DMVA 42240114 – ASPHALT APRON AND CONCRETE PARKING PAD REPAIRS

MUIR AIRFIELD – AREA 19

FORT INDIANTOWN GAP

DMVA Addendum 22 JULY 2025

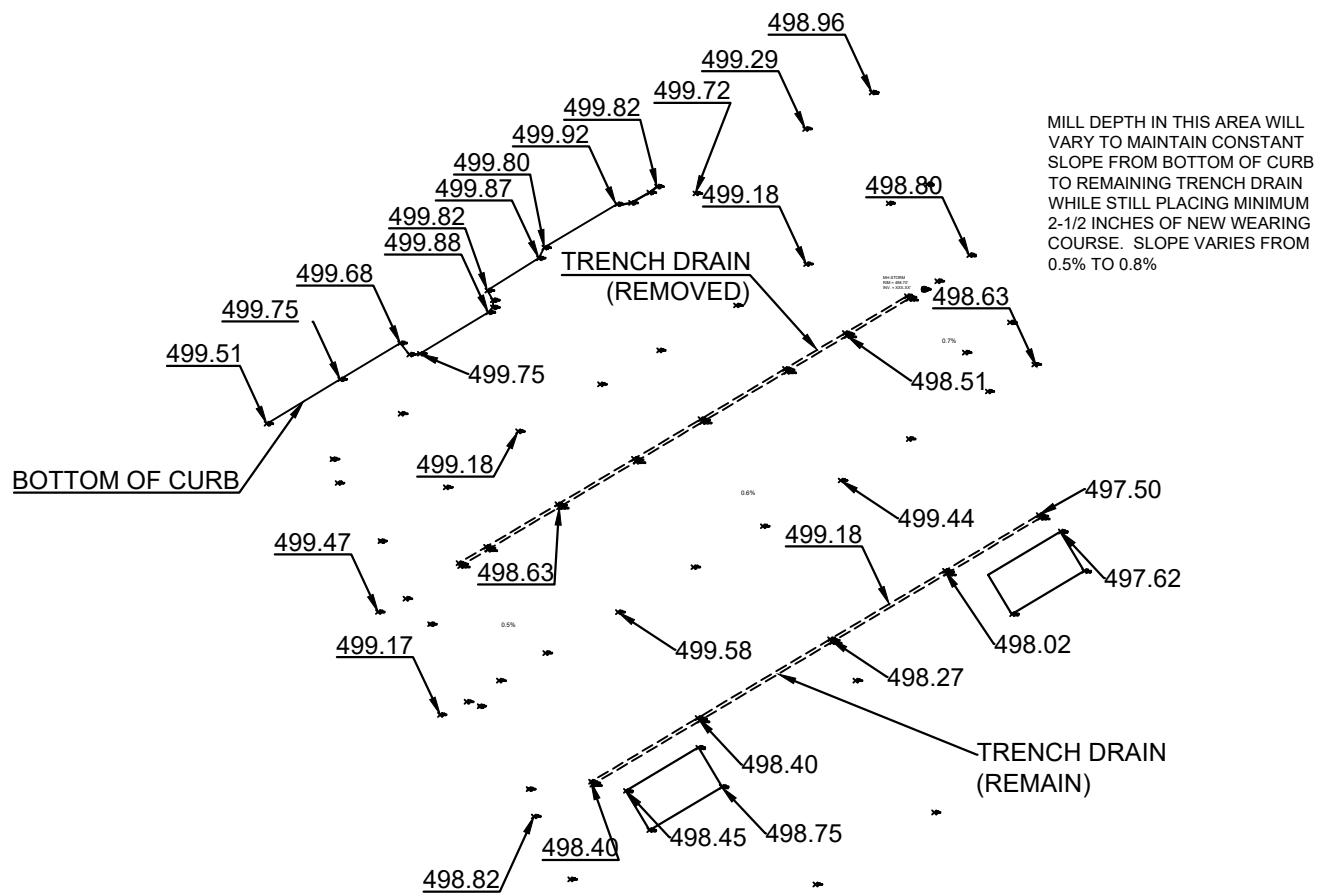
E. Access to construct Perimeter Road:

The contractor shall provide 2 each locks and keys for access to the fire dept gate and northwest gate. The contractor will be responsible for maintaining physical control of all keys and opening/closing the gates as required. The gate will be closed after each entry and/or departure unless the work being performed, or a contractor remains within 25 feet of the gate. The contractor is responsible for securing the gate at the end of each shift and/or during extended breaks. The contractor lock will be locked through the existing chain and the MUIR AF lock in a daisy chain

fashion (see pic) to enable both parties the ability to access the airfield. In the event the locks are not properly locked in a daisy chain fashion, and access is needed, MUIR AF and/or emergency personnel will remove the contractor lock at the contractor's expense.
